4328 Brooklyn Ave NE

Recommendation Meeting

SDCI: 3036008-LU

February 28, 2022

Priorities & Board Recommendations: Massing & Materials

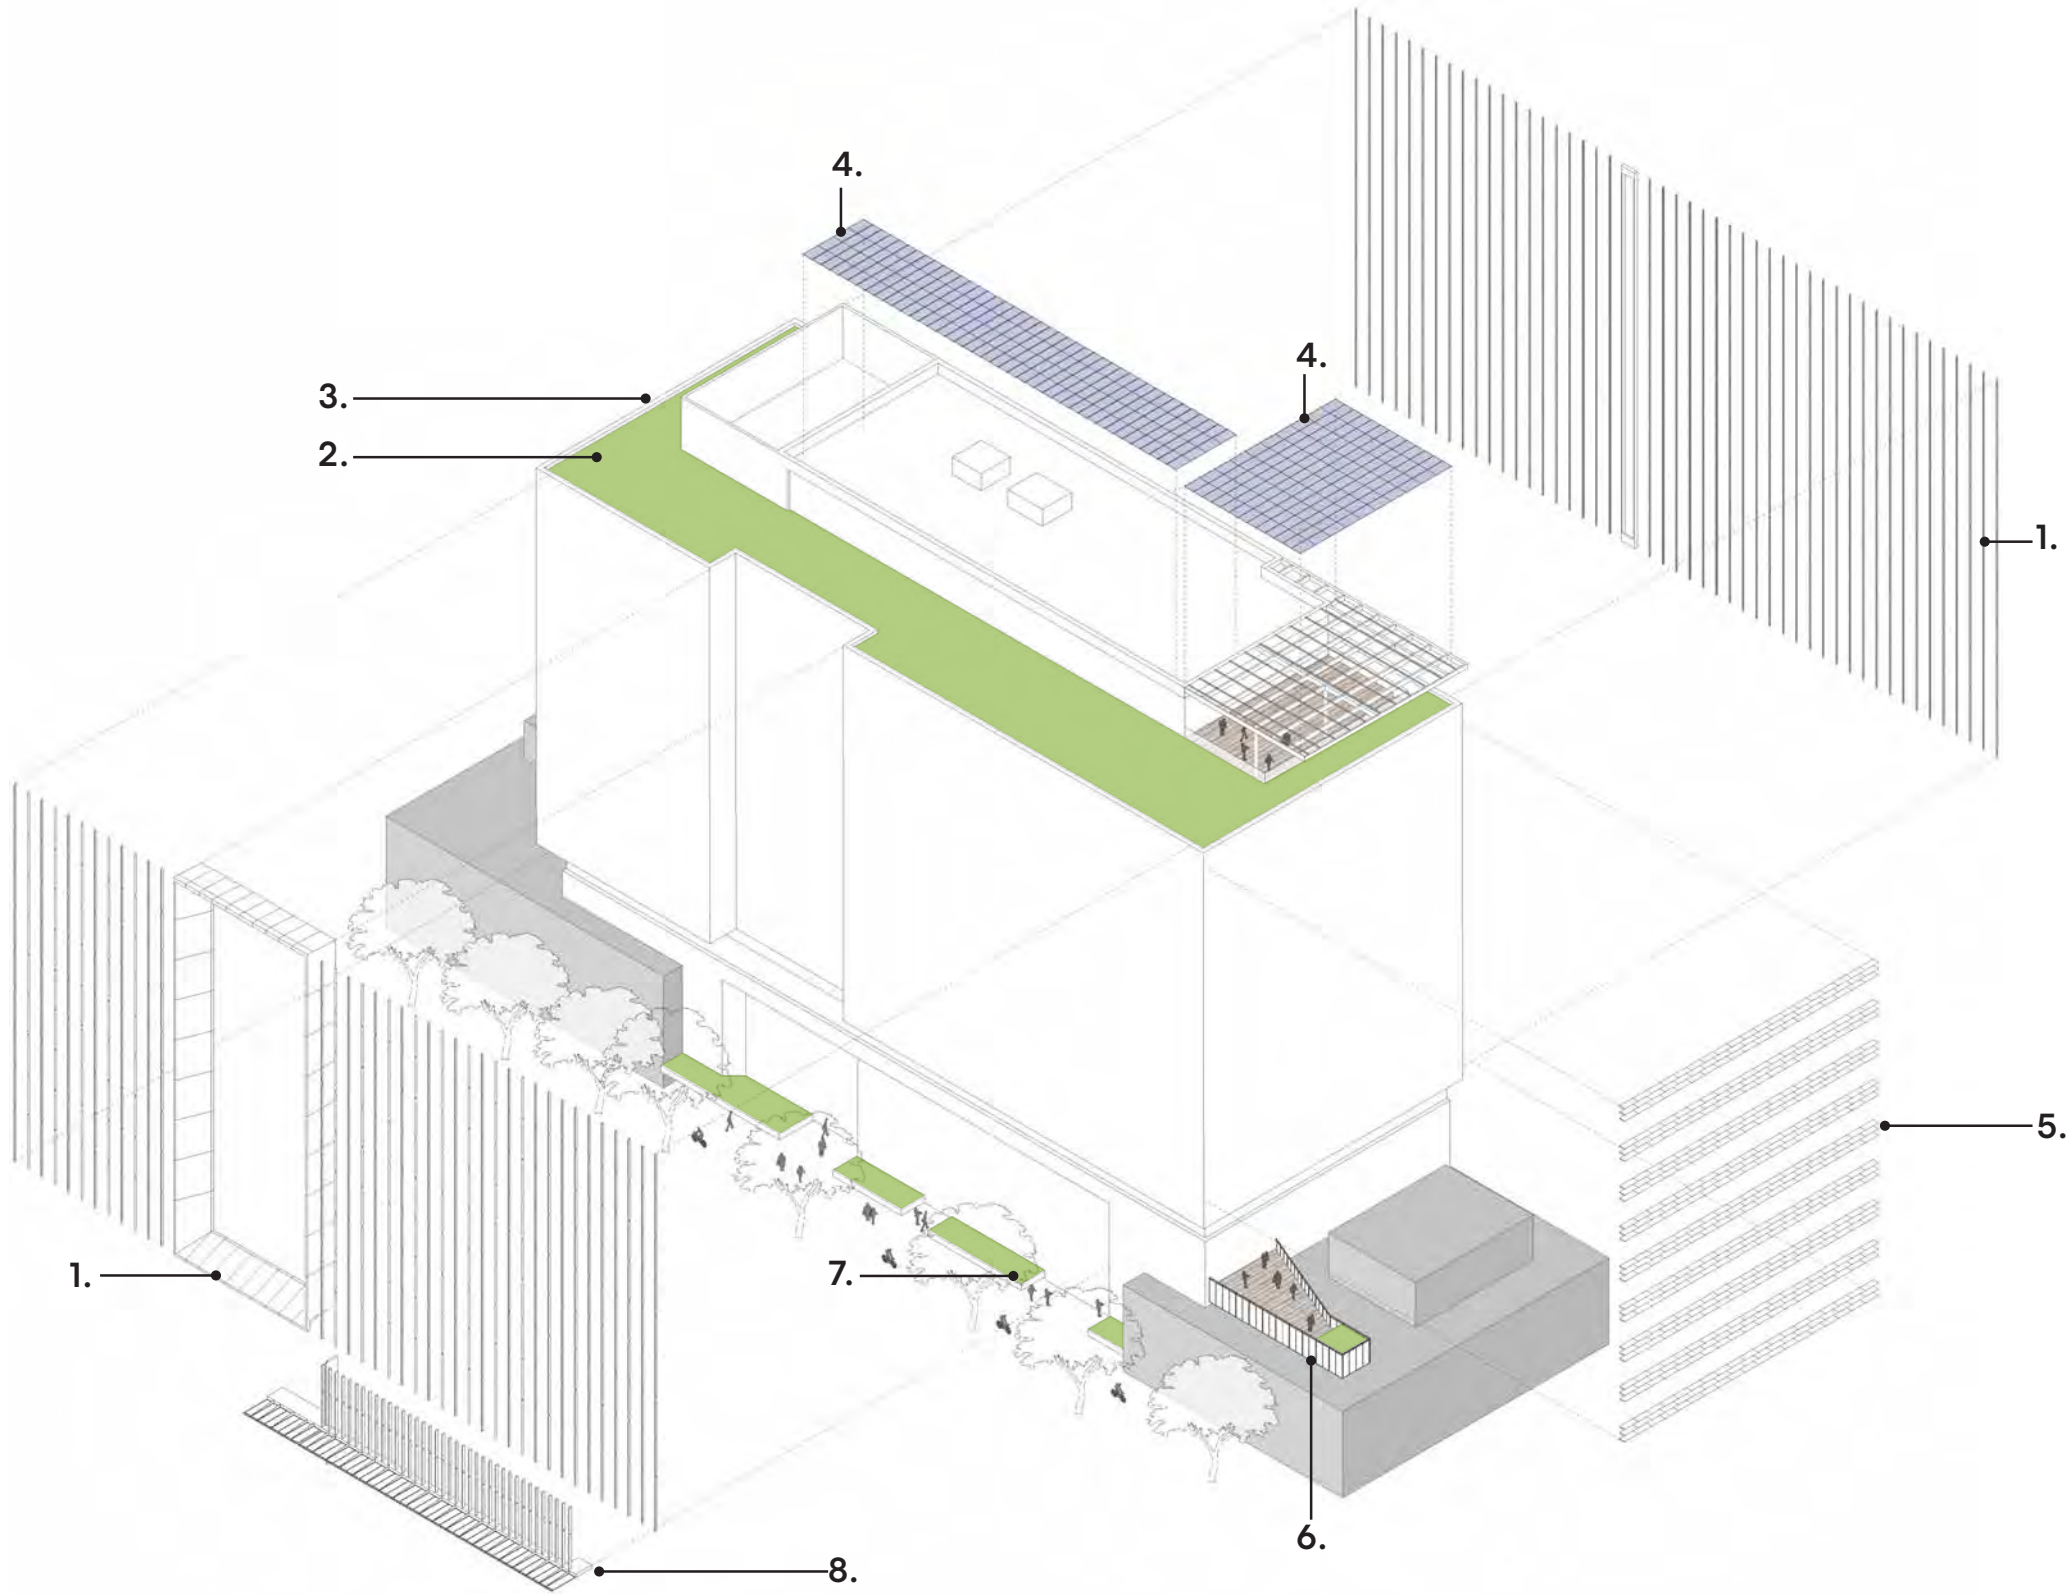
- 1b) *The simple elegance of the building should be further enhanced by context-sensitive massing and cladding responses on each facade with additional detail, layering, and thoughtful material application as opposed to a single cladding wrap*

The building skin has been designed in response to its unique contextual conditions which includes an existing transit station, the existing and emerging urban form, and the opportunity to create visual relationships to the UW Tower and the UW campus. These specific responses include the articulation of a community scale “aperture” facing west to the UW Tower courtyard, and the articulation of the tower facades as a ‘light assemblage’ of planar elements that incorporate visual texture, scale, performance, and complexity

1. The tower aperture and profiled curtain wall mullions contribute to visual texture, scale and complexity and create an overall cohesive architectural expression (DC2-B.1, DC2-2c, DC2-2h, DC4-A.1, DC4-1a, DC4-1c)

2. An extensive coverage of green roof provides visual interest for the rooftop amenity space (DC2-6j, DC3-B.1, DC3-C.2)
3. In response to a northern exposure, the north facade is treated as a smooth, planar glass element providing further differentiation from the remaining facades (DC2-2c, DC4-A.1, DC4-1c)

4. Photovoltaic panels contribute to energy performance
5. Horizontal louvers serve a performative function and create a layered facade with visual texture, scale and complexity (DC2-2c, DC4-A.1, DC4-1c)

6. An extended roof deck at level 2 provides planting areas and views to the pocket park
7. Raised bio-retention planters define the building entries and create an engaging, secondary level of scale along the sidewalk (CS2-2a, PL1-1a, PL3-1a, PL3-C.1, PL3-3b)

8. An overhead canopy with vertical fins provides shading and creates a layered facade expression with visual texture, scale, and complexity (DC2-B.1, DC2-D.2, DC2-2c, DC4-1c)

Priorities & Board Recommendations: Massing & Materials

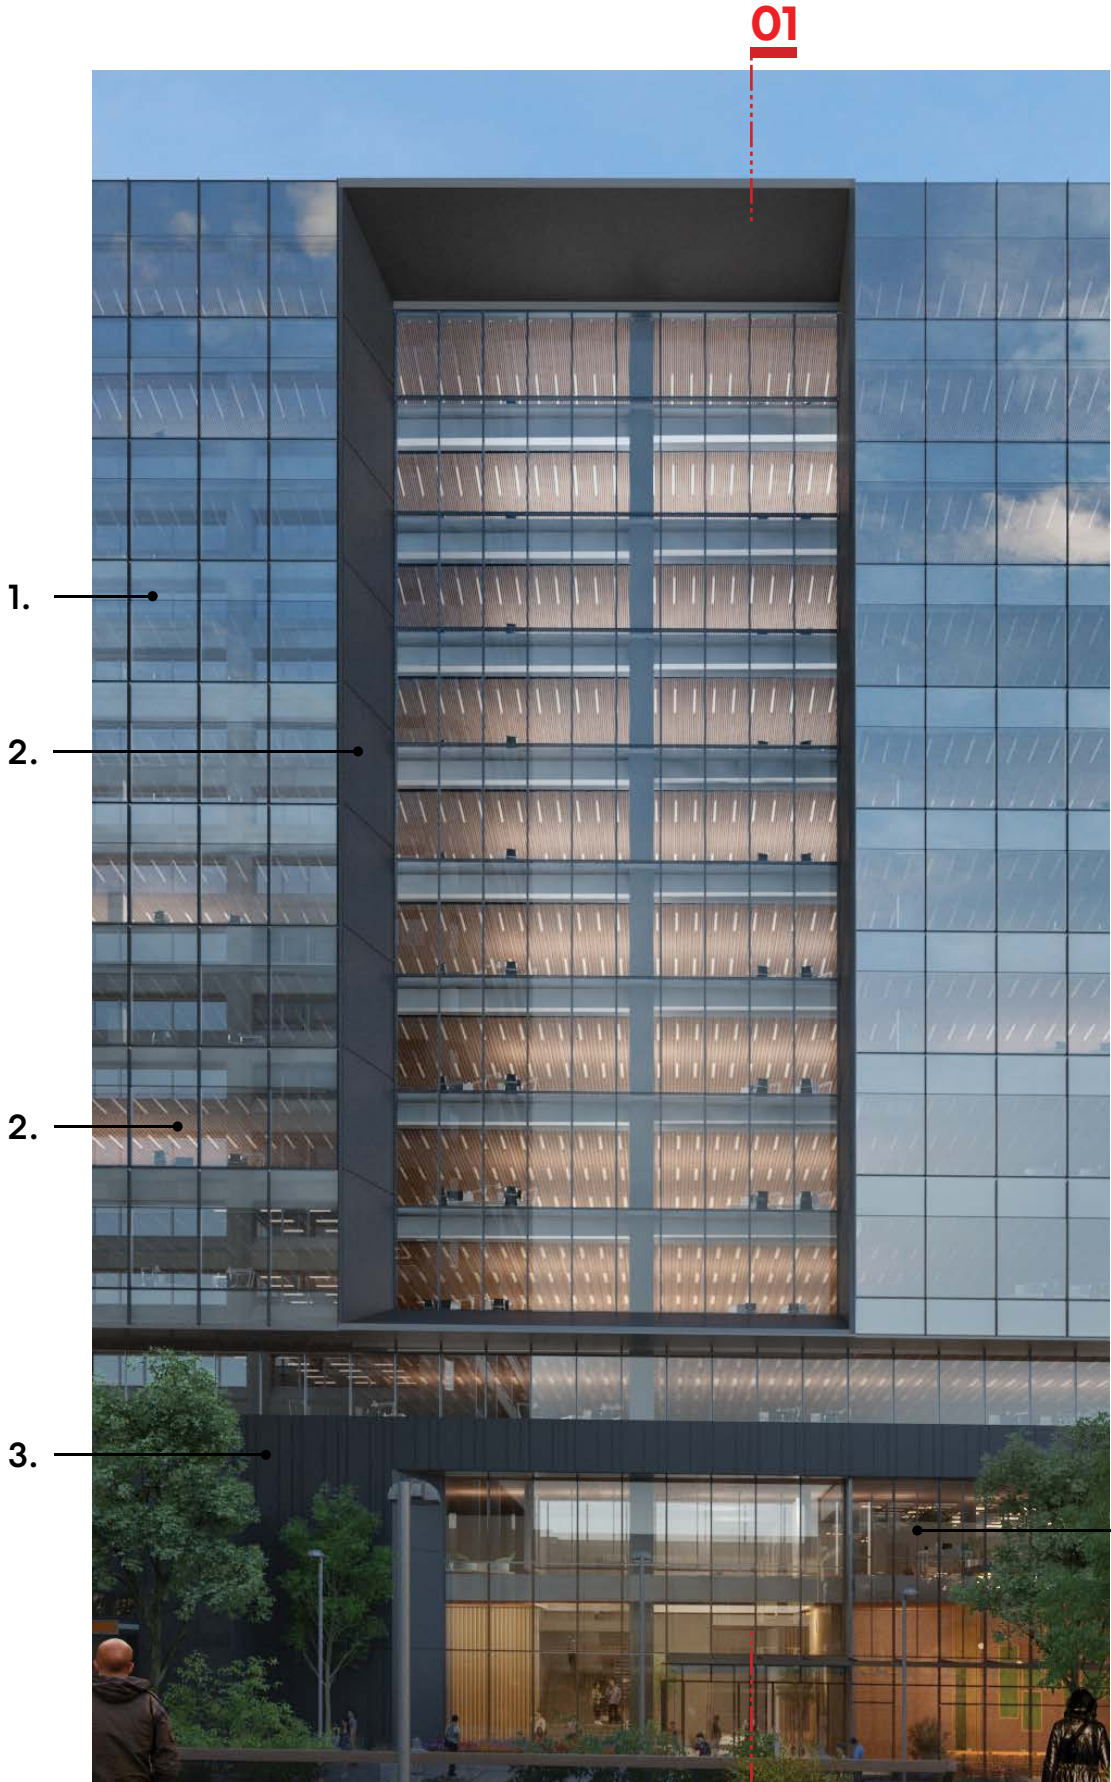
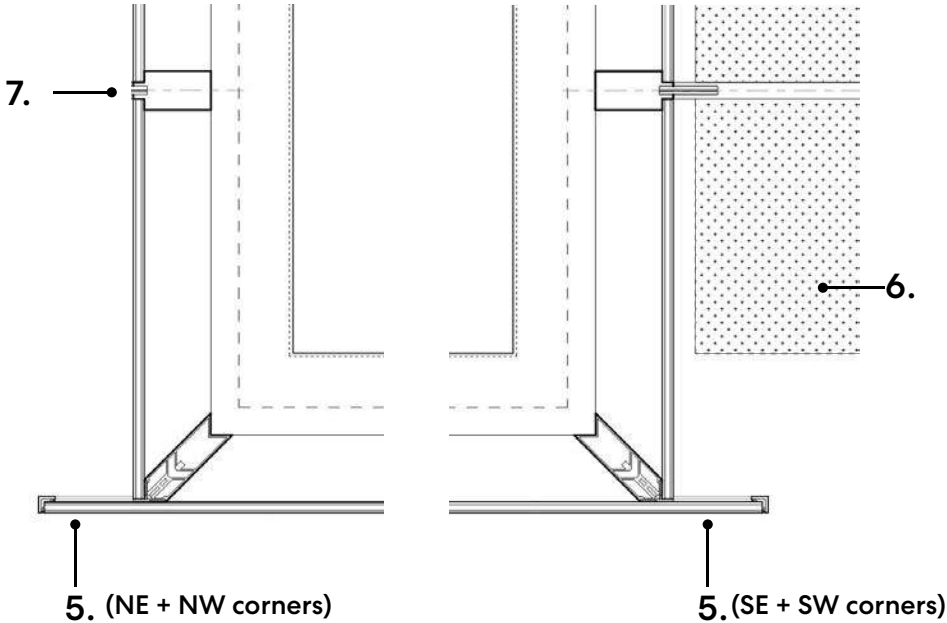
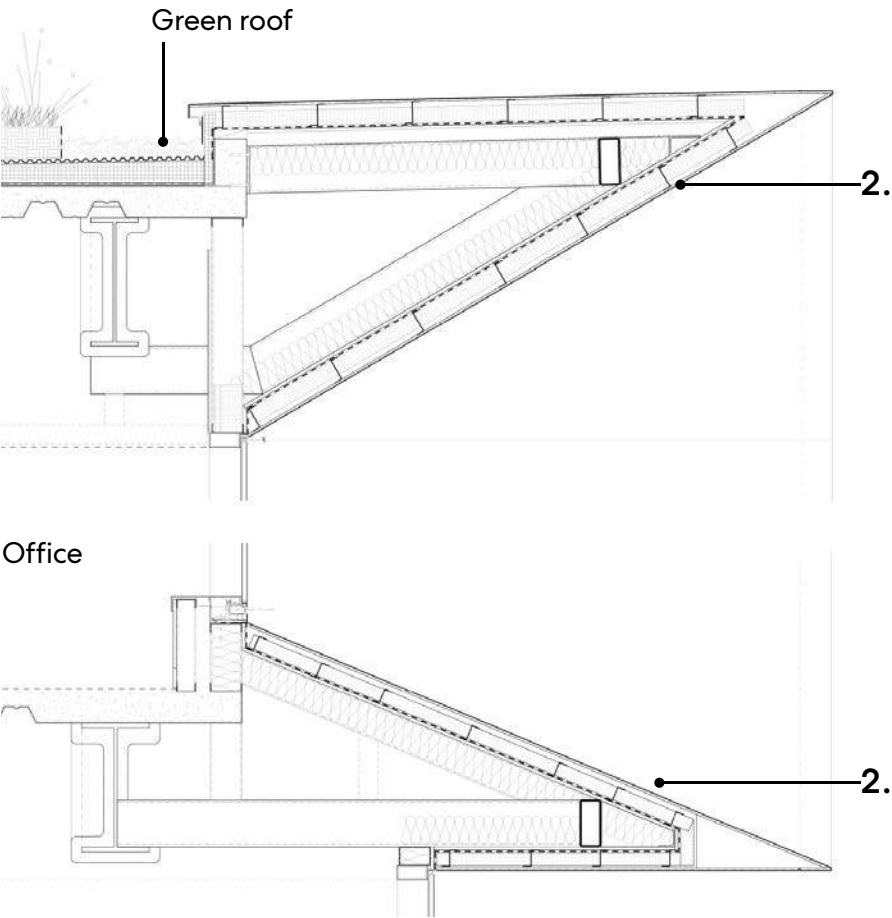
- 1a) *The simple massing with large inset responded to the surrounding context and marked the building's features well*
- *the shape is simple and elegant but requires high-quality materials and thoughtful detailing for the skin to “sing”*
 - *explore innovation in the use of materials*
 - *the massing responds well to the complexities of the site, given the two transit station entries*
- 1b) *The simple elegance of the building should be further enhanced by context-sensitive massing and cladding responses on each facade with additional detail, layering, and thoughtful material application as opposed to a single cladding wrap*

1. The lantern like tower volume is lifted above the nested podium creating a visual sense of compositional lightness (CS2-A.2, DC2-B.1, DC2-2a, DC2-2c)

2. The tower aperture and profiled curtain wall mullions contribute to visual texture, scale, and complexity and create an overall cohesive architectural expression (DC2-B.1, DC2-2c, DC2-2h, DC4-A.1, DC4-1a, DC4-1c)

3. Podium cladding is complimentary with the transit station (DC2-1a, DC2-2a, DC2-2c)
4. Vertical fins within the podium frame create a layered facade with visual texture, scale, and complexity (DC2-B.1, DC2-D.2, DC2-2c, DC4-1c)

5. The tower's east and west facades are extended to further articulate an assemblage of planar elements and to create further distinction from the north and south facade expressions (DC2-D.2, DC2-2h, DC4-1c)(detail.2)

6. Horizontal louvers at the south facade serve a performative function and create a layered facade with visual texture, scale, and complexity (DC2-2c, DC4-A.1, DC4-1c)

7. The north facade is treated as a smooth, planar glass element providing further differentiation from the remaining facades (DC2-2c, DC4-A.1, DC4-1c)
